Access Compliance Report Public Rights-of-Way (Pedestrian Signals)

Main Street: KATELLA_AVE Cross Street: GILBERT_ST Location: SE

ADA ID: SGRK210916140447 Signal Type: One Push Button-Non APS Overall Compliance: No Severity Scores: BTN 1: 25 BTN 2: N/A No BTN: N/A

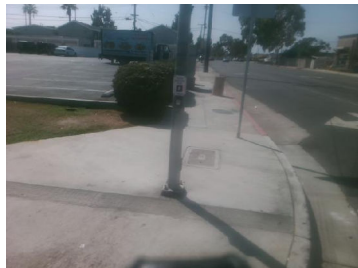
OC Std/PROW: R404.2, R404.3

Possible Solutions: Remove and Replace Clear Space.
